MEMORANDUM

Hunters Point Building 364 Removal Action Findings

Building 364 Removal Actions:

Black Beauty Sandblast Grit:

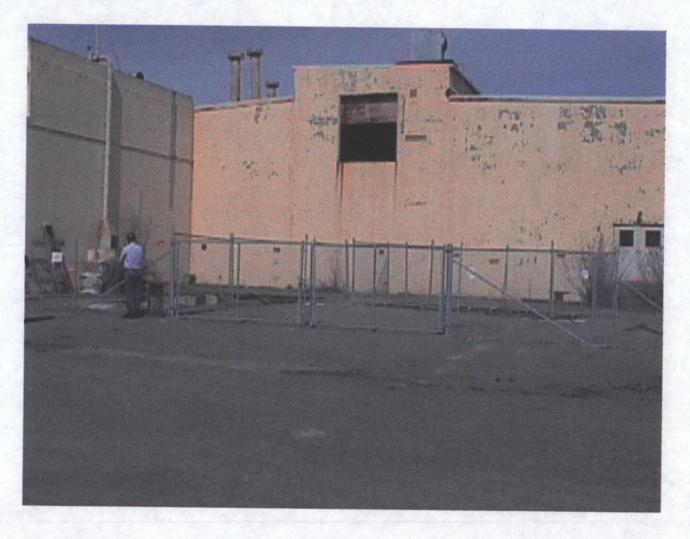
I analyzed an area in Parcel E impacted by black beauty sandblast grit to determine whether or not this material meets the requirements for removal as a radium-226 waste material. The spectrum on very close scrutiny does reveal a slightly elevated peak at 352 kev, a region associated with lead-214 (Pb214) which is a radium decay daughter. The Navy has agreed to remove and dispose of the sandblast grit even though the radium concentration in the grit may not require it.

Sump Removal Pit Wall Spectrum Analysis

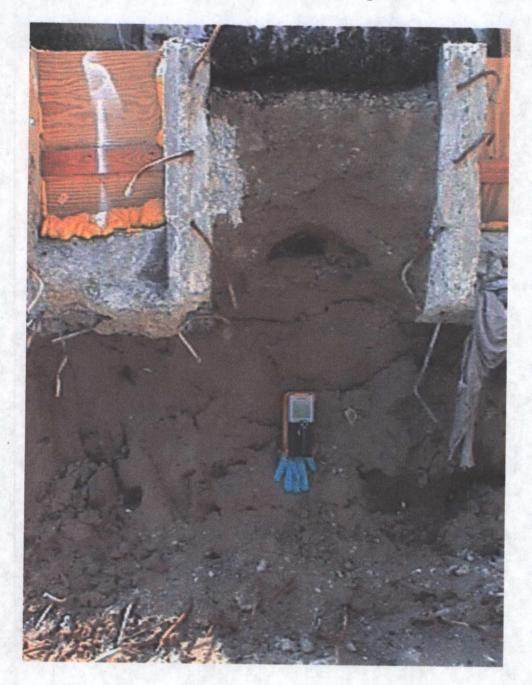
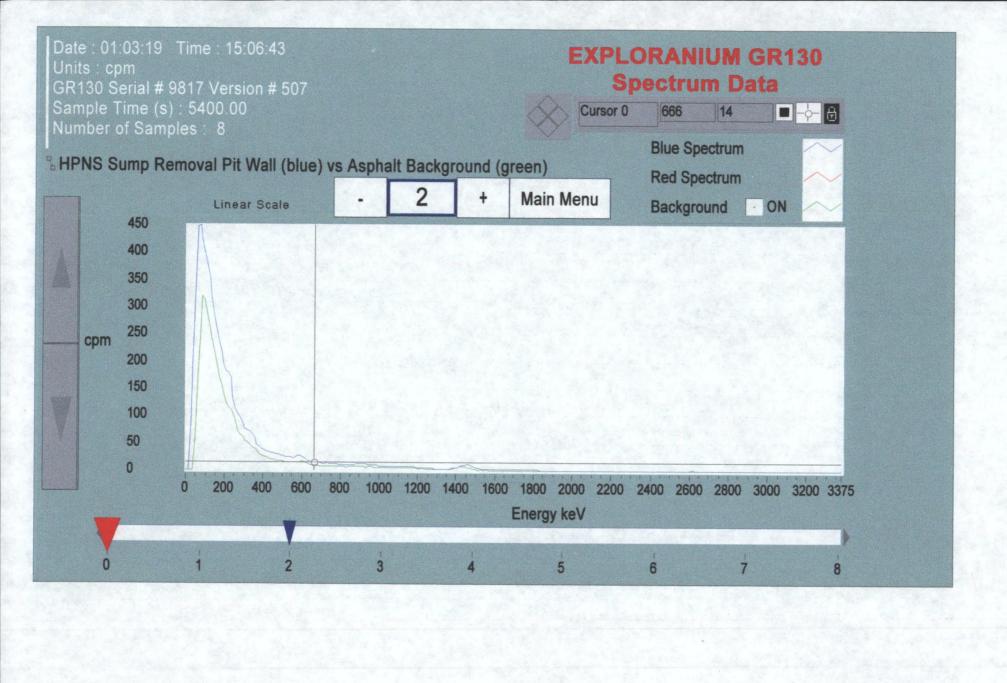
While this area exhibited the highest gross gamma reading in the pit, the gamma spectrum shows that no gamma emitting radioactive contaminant is present. The elevated background was from the configuration of the wall's undercutting and nearby concrete structures which changed the counting geometry and thus increased the probe's detection efficiency. This translates into a slightly higher peak in the Compton scatter region, from zero to about 400 kilo-electron-volts (kev), of the spectrum. With this one exception, the wall's spectrum compares well to a background spectrum taken on unimpacted asphalt near Building 364. No Radium-226 (Ra226), Cs-137, or other radionuclide contaminants of concern are present in the spectrum.

Sump Removal Pit Wall Spectrum Analysis

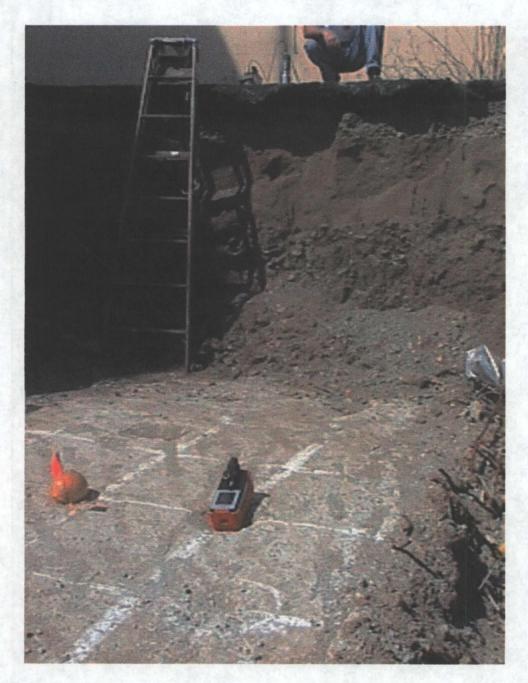
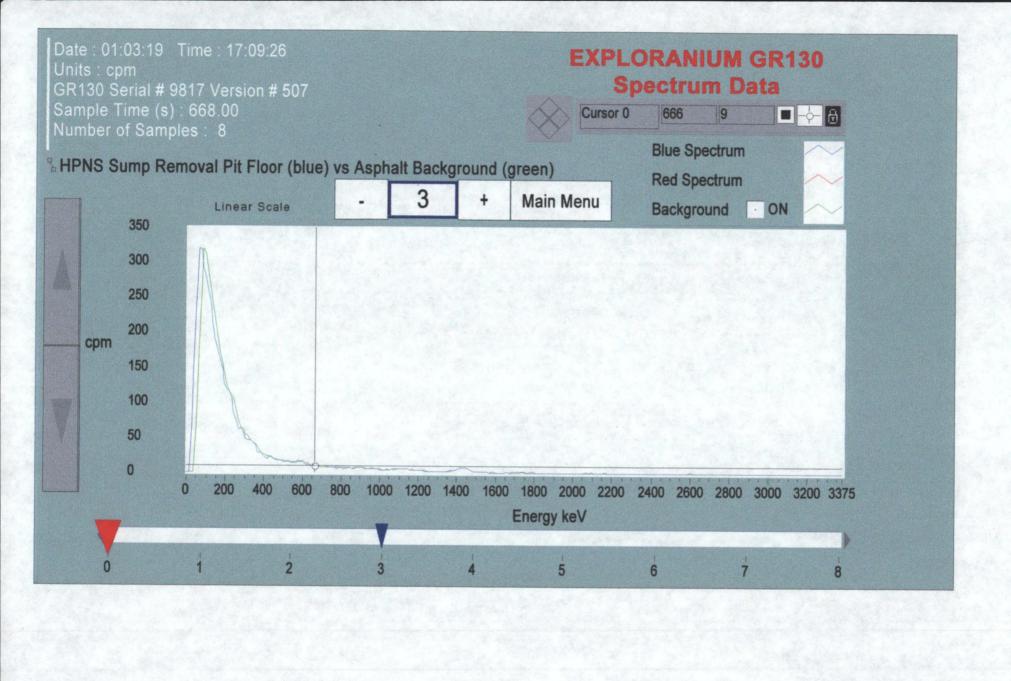
One small indentation in the concrete floor had slightly higher gamma counts. The

indentation was made by workers while removing a small area of fixed contamination on the concrete floor. The spectrum of this area revealed no evidence of any residual radioactive contamination.

B364 Vent Wall Spectrum Analysis

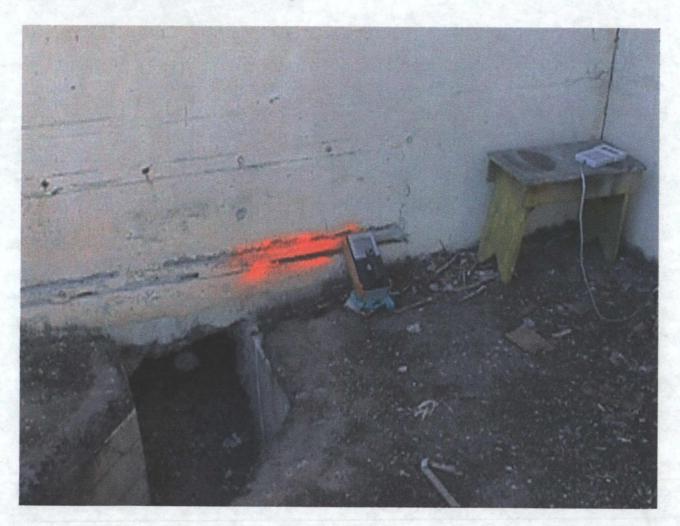
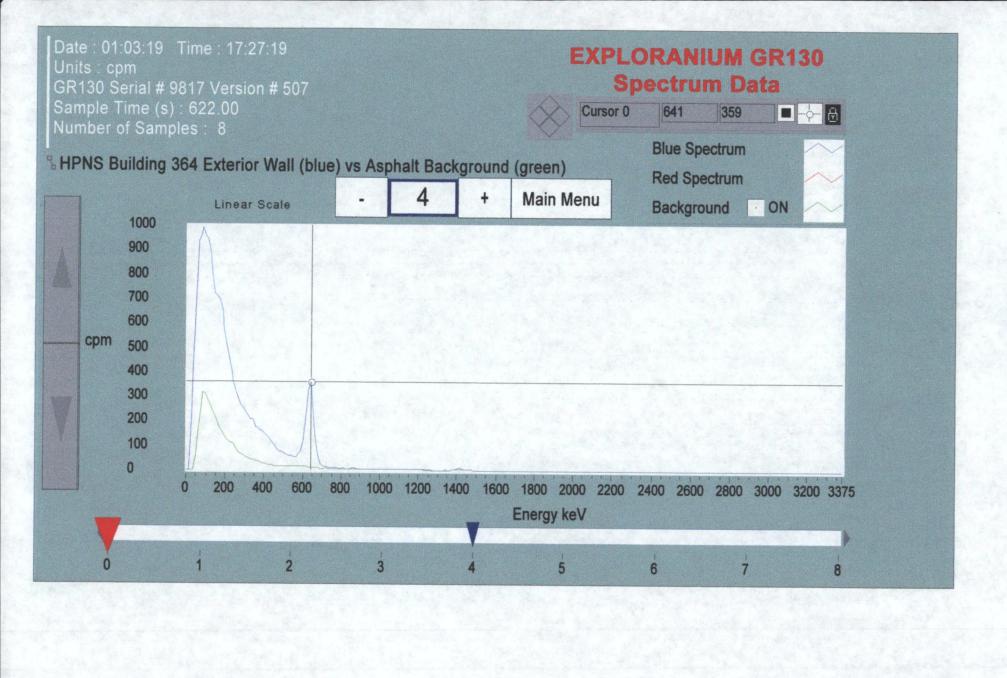
A spectral analysis of the exterior wall of Building 364 exhibited conclusive evidence that considerable Cs137 contamination is present. The Cs137 is localized in a seam between the original wall and a concrete patch that was applied to an old ventilator duct that passed through the exterior wall. This area requires remediation.

B364 Drain Pipe Spectrum Analysis

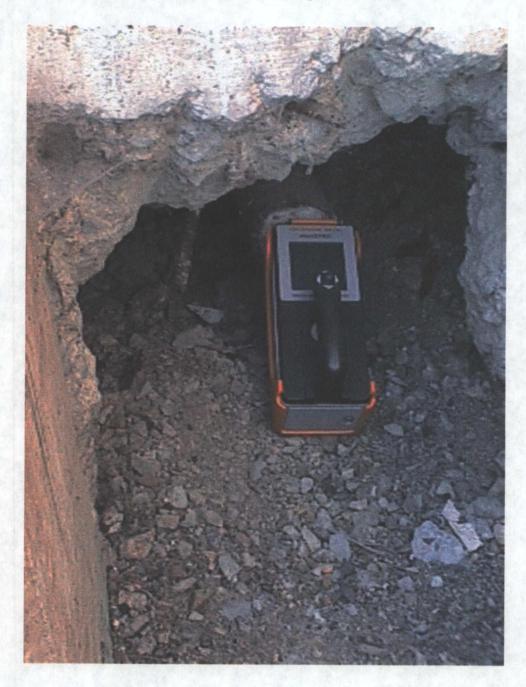
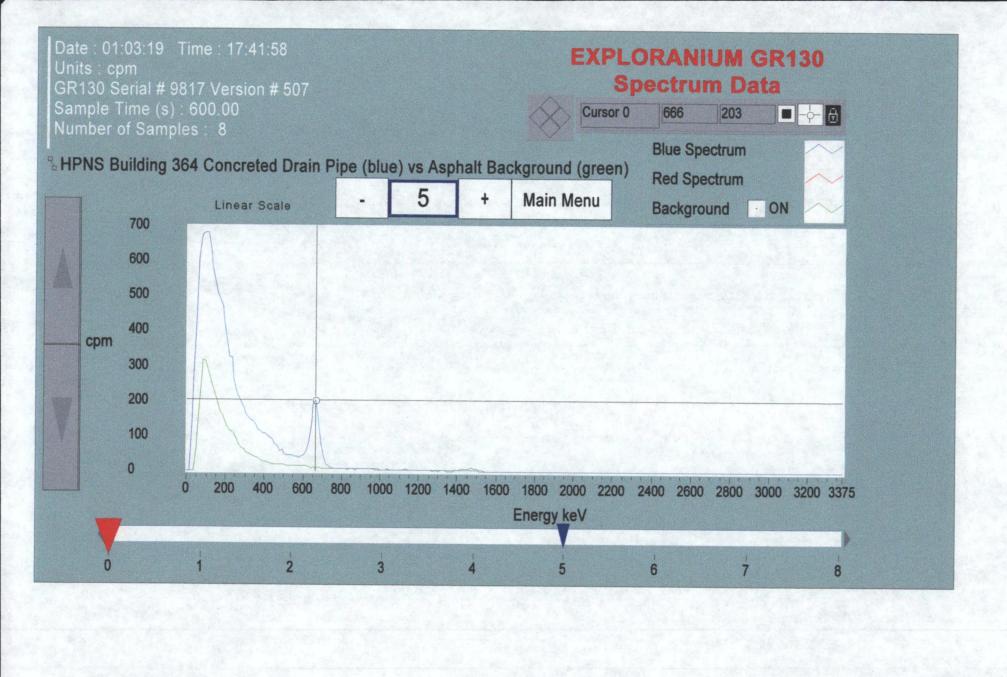
A concrete fill iron drain pipe is located under the building just below the ventilator duct area. The pipe also exhibited considerable Cs137 contamination which was confirmed by the spectrum data. A spectrum peak at around 662 kev indicates the presence of Cs137. This pipe should be removed for radiation waste disposal.

Peanut Spill Removal Pit

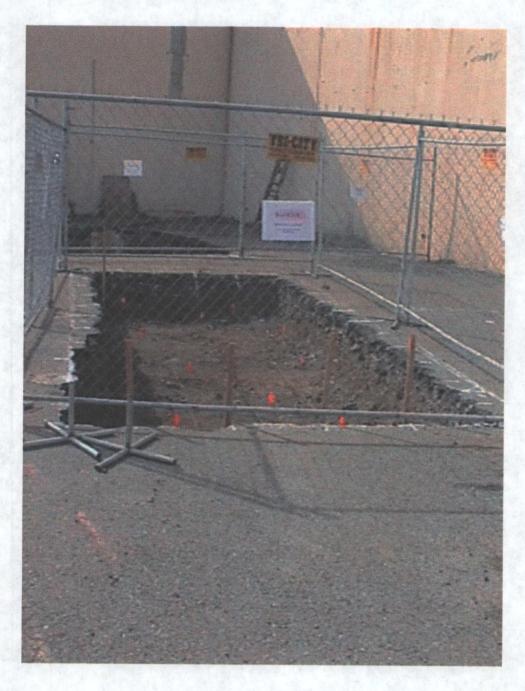
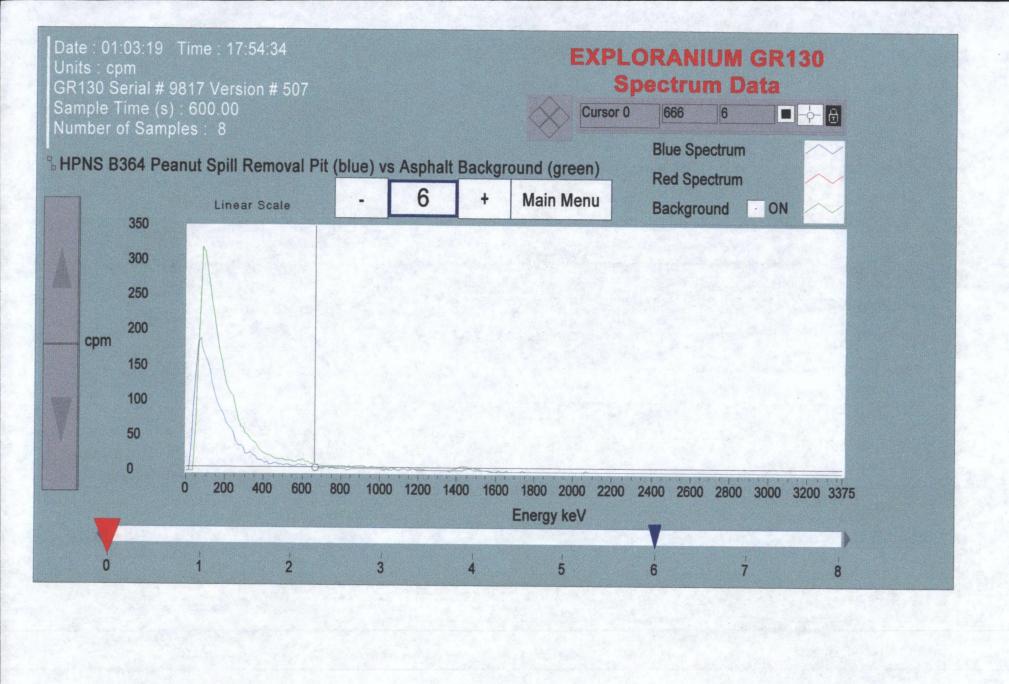
My gross gamma survey did not reveal any leveled gamma areas. So, I chose, as closely as I could recall, the region in the spill where the last Cs137 hit had been detected by the GR-130. The spectrum data did not reveal the presence of cesium or any other radionuclide contaminant.
